**Planning Department
Transportation Development Services**

**Re: TLC Pet and Uptown Cat Hospitals, 1300 Wyoming Boulevard, N.E.
Traffic Circulation Layout**
Engineer's/Architect's Stamp dated 10-06-14 (J20-D027)

Based upon the information provided in your submittal received 10-07-14, the above referenced plan cannot be approved for Building Permit until the following comments are addressed:

1 Architectural Site Plan
Scale: 1"=10'-0"

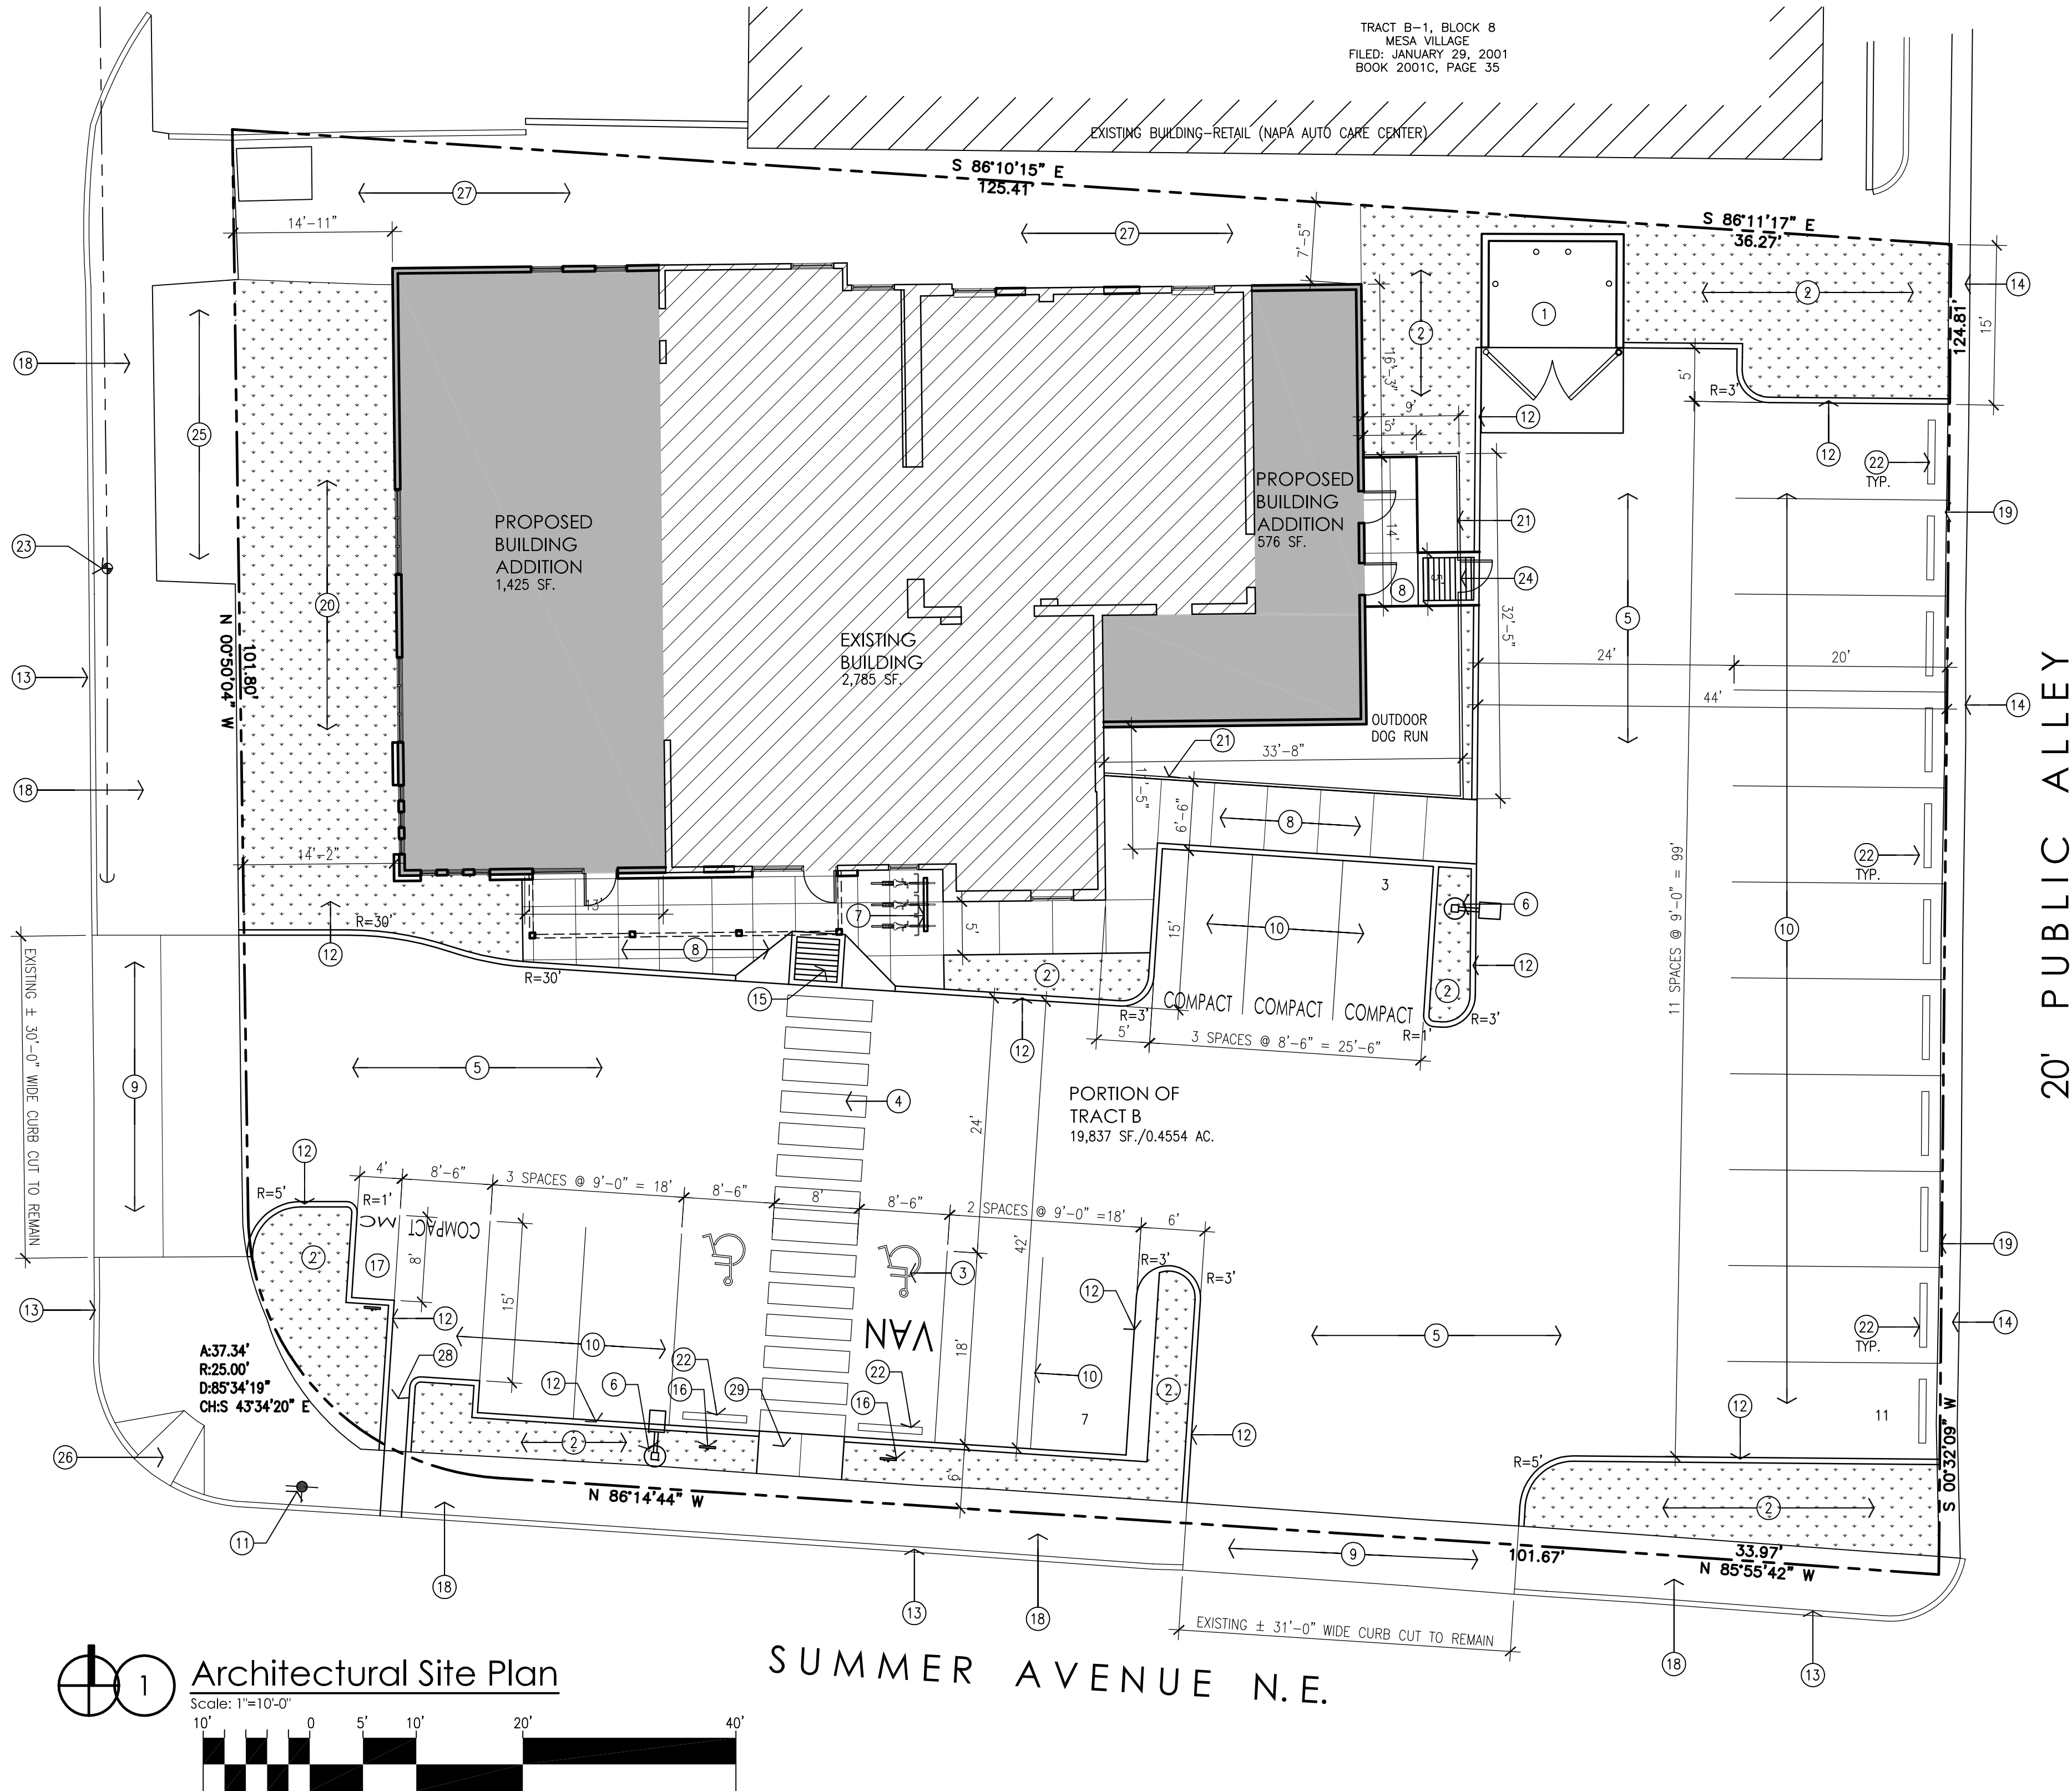
1. Please provide a vicinity map with the location of the site development in relation to surrounding streets.
2. Please provide a legend for the various line-types and hatching.

3. Identify the existing right-of-way width, medians, and street widths for Wyoming Boulevard and Summer Avenue.
4. In addition to being too close to the Summer Avenue intersection, the existing drivepad on Wyoming Boulevard does not match up with the driving aisle. Revise the existing drivepad to match up with the driving aisle along the south side of the access.

5. On the southwest corner of the parking lot, make a correction from "3 Spaces @9'-0" = 18' " to " 2 Spaces@9'-0" =18' ".
6. For Keyed Note 16, the ADA van accessible sign must have the required language per 66-7-352.4C NMSA 1978 **"Violators Are Subject to a Fine and/or Towing."**

7. The ADA access aisle shall have the words **"NO PARKING"** in capital letters, each of which shall be at least one foot high and at least two inches wide, placed at the rear of the parking space so as to be close to where an adjacent vehicle's rear tire would be placed. (66-1-4.1.B NMSA 1978)

8. See Figure 23.7.2 of the DPM for end of parking aisle islands. Change the curb radii from 1 foot to 3 feet where shown on parking aisle islands near the end of

the parking spaces. Curb radii should be 15 feet for passenger vehicle maneuvering.

9. Graphically, it appears that it will be difficult to incorporate a 6-foot wide flat ADA-accessible path in front of the door in addition to a ramp with a 12:1 slope. (Make sure that both the 12:1 ramp and a 6-foot pathway can be incorporated. The ramp is only drawn at a 5-foot length.)

10. Call out curb height for Keyed Note 12. Keyed Note 12 needs to correctly point to curb for access off of Wyoming Boulevard.
11. For ease of refuse vehicle maneuvering, move the refuse at least a few feet to the east away from the curb.

12. Indicate what pavement thickness will be used for the parking lot.
13. The proposed landscaping at the access off of Summer Avenue may interfere with the sight distance. Provide clear site triangle. (See DPM Manual Page 23-74 of the DPM for Mini Clear Site Triangles for Driveways.)

14. Please add the following note to the clear sight triangle: "Landscaping and signage will not interfere with clear sight requirements. Therefore, signs, walls, trees, and shrubbery between 3 and 8 feet tall (as measured from the gutter pan) will not be acceptable in this area."
